## **SOUTH SCHILLINGER COMMERCIAL PARK** **SUBDIVISION, PHASE TWO**

APPLICATION NUMBER 18 DATE April 3, 2008

REQUEST Subdivision

# DETAIL SITE PLAN

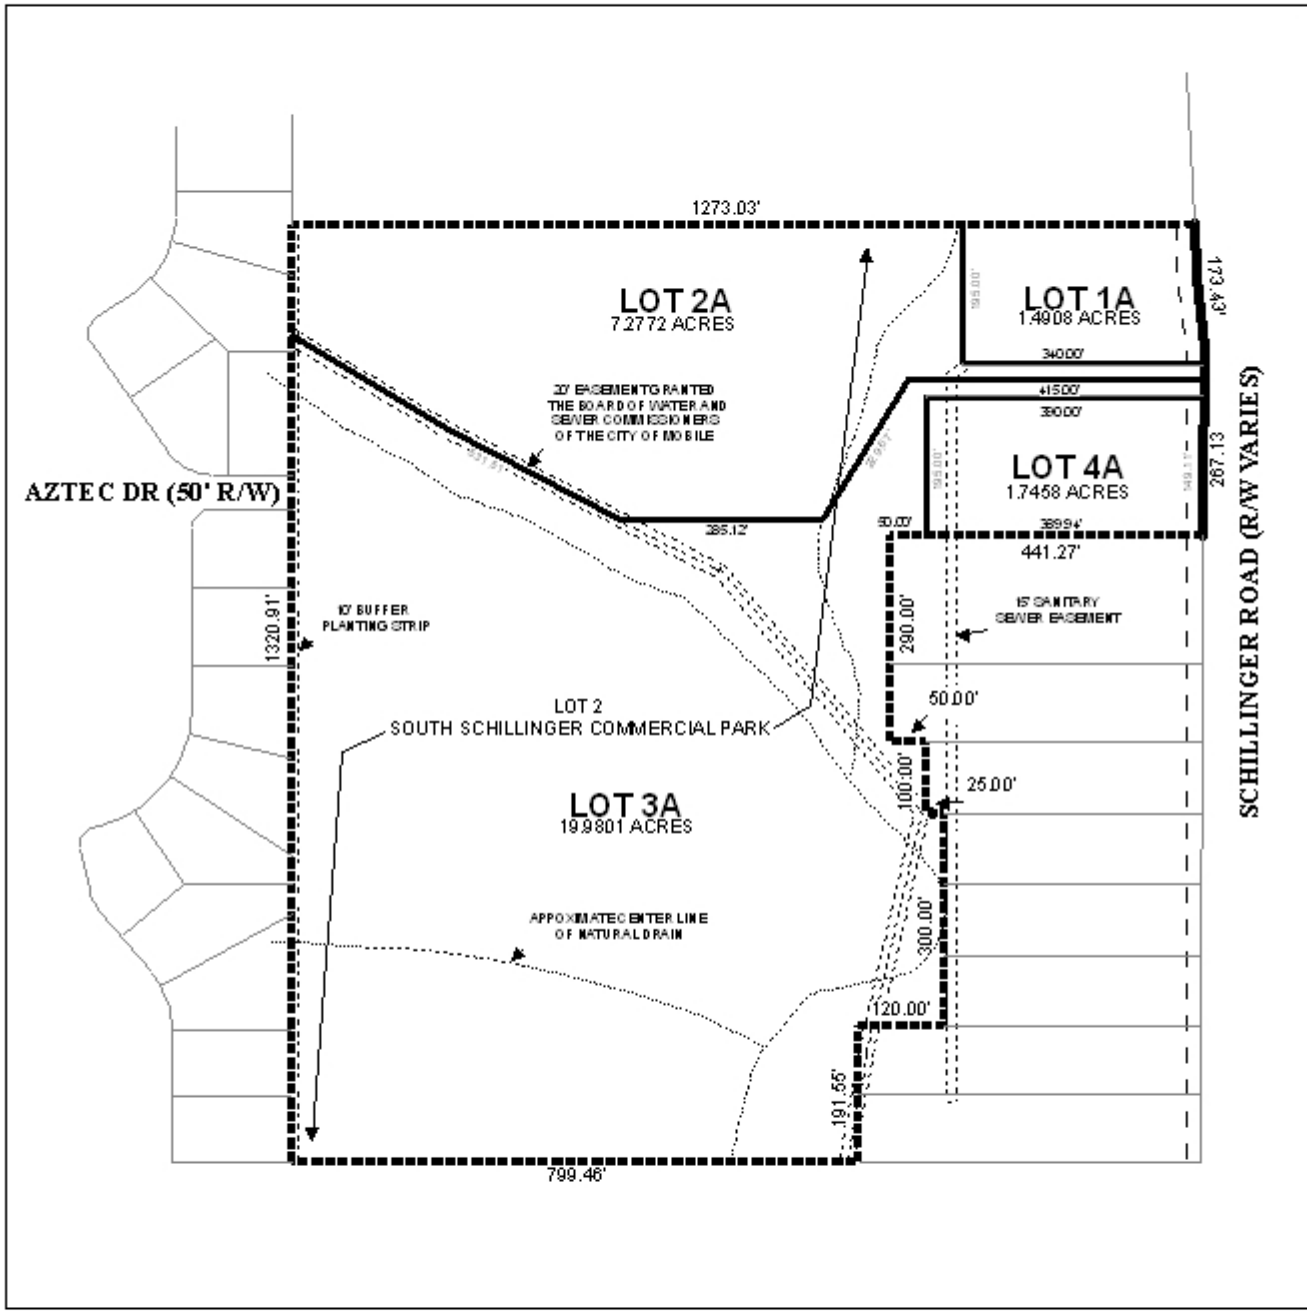
foot of right-of-way to provide access by means of a public street to Lots 2A and 3A. As proposed the preliminary subdivision provides access to Lots 2A and 3A by way of allowing each lot a 25-foot flag pole to Schillinger Road. Additionally, as this is a commercial subdivision, access to the street stub (Aztec Drive) should be denied and barricaded.

As illustrated on the preliminary plat the proposed subdivision would provide Lot 2A and 3A with 25-feet of road frontage along Schillinger Road. As mentioned previously access management is a concern. Due to the uncertain development of these undeveloped 25± acres, a Traffic Impact Study should be provided to Traffic Engineering and Urban Development to access existing and future traffic patterns within the area. It should be noted that within these flag lots are an existing extensive freestanding sign. As subdivision as proposed with the location of this sign may cause undue safety concerns with vehicles entering and exiting the site.

Another concern with the development of Lots 2A and 3A and the access to Schillinger Road is the close proximity of the existing curb cut to Lot 1A, as illustrated on the aerial map the existing curb cut is approximately 55'± North of the access provided to Lots 2A and 3A. While this access is existing, the increase in vehicular traffic and the traffic situation on Schillinger Road further warrants the submittal of a Traffic Impact Study.

- 1) the submittal of the completed Traffic Impact Study as required by Traffic Engineering and Urban Development prior to the development of Lot 3A;
- 2) the illustration of a 10-foot buffer planting strip and a minimum 6-foot high solid wooden fence along the West property line of the development;

- 3) the dedication of 50-feet of right-of-way to provide access by means of a public street to Lots 2A and 3A;
- 4) the placement of a note on the Final Plat stating that the development be denied access to Aztec Drive and Aztec Drive be barricaded;

- 6) revision of the plat to label the lot with its size in square feet, or placement of a table on the plat with the same information;
